POEIMA SUBDIVISION

Engineering Comments: FINAL PLAT COMMENTS (should be addressed prior to submitting the FINAL PLAT for acceptance and signature by the City Engineer):

APPLICATION NUMBER 3 DATE December 19, 2019

DETAIL SITE PLAN

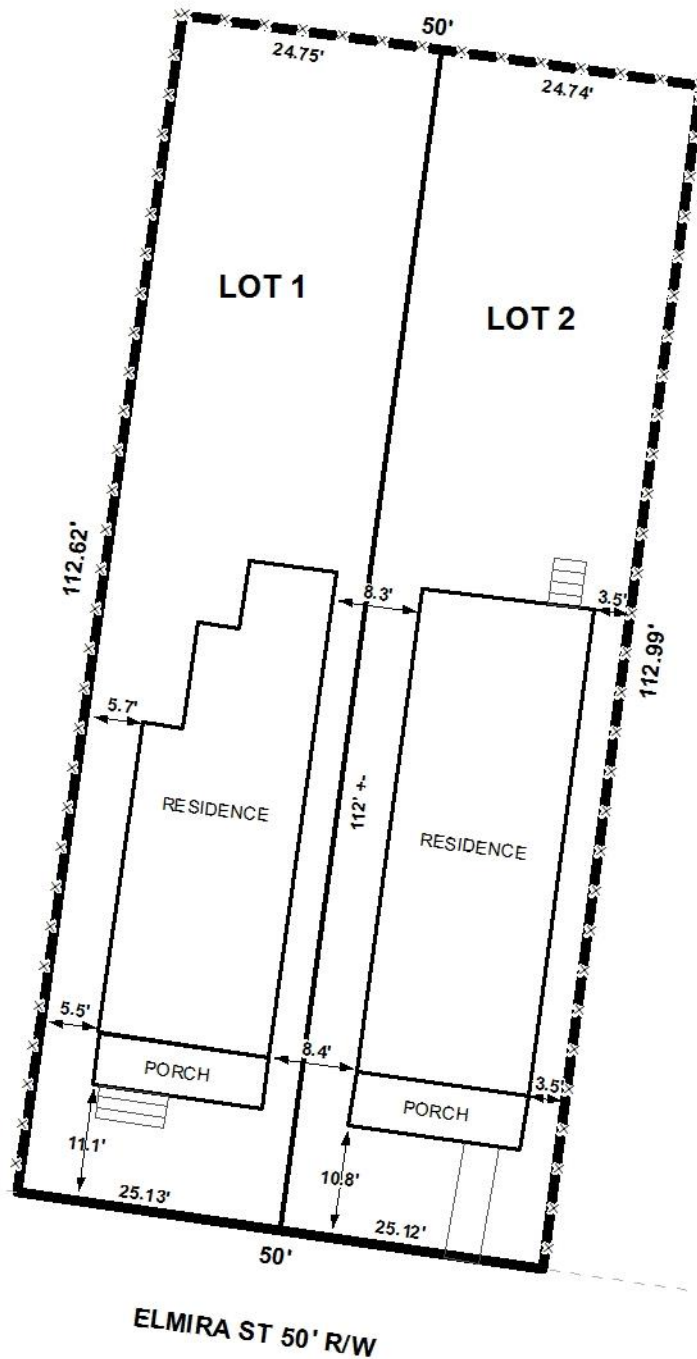
- B. Check and verify the location of the POB – as shown or at the SE corner of LOT 2.
- C. Provide the Surveyor's Certificate and Signature.
- D. Provide the Surveyor's, Owner's (notarized), Planning Commission, and Traffic Engineering signatures.

Both proposed lots front Elmira Street, a minor street with curb and gutter. As such, the preliminary plat illustrates a compliant 50 foot right-of-way; therefore no frontage dedication would be required

As illustrated, the preliminary plat does not depict a minimum setback requirement. The Subdivision Regulations would typically require a 25 foot front yard setback. However, it is important to note that the subject property is located within the Oakleigh Garden Historic District and as such would automatically be granted relief from the normal building setbacks and site coverage limitation via the more flexible Historic District Overlay under Section 64-3.G. of the Zoning Ordinance. Therefore, if approved, it is recommended that Section V.D.9. of the Subdivision Regulations be waived, and that a note be placed on the Final Plat stating that all setbacks shall be determined by Section 64-3.G. Historic District Overlay requirements of the Zoning Ordinance.

The proposed lots will not meet the minimum size requirements (60' width at the building setback line and 7,200 square feet of area) of Section V.D.2. of the Subdivision Regulations and will exceed the maximum depth allowed per Section V.D.3. However, as sub-standard size lots are common in the vicinity and within historic districts, waivers of Sections V.D.2. and V.D.3. could be appropriate. Additionally, the lot size labels in both square feet and acres should be retained on the Final Plat or a table should be furnished on the Final Plat providing the same information.

- 1) placement of a note on the Final Plat stating that all setbacks shall be determined by Section 64-3.G. Historic District Overlay requirements of the Zoning Ordinance;
- 2) retention of the lot size labels in both square feet and acres on the Final Plat or the furnishing of a table on the Final Plat providing the same information;
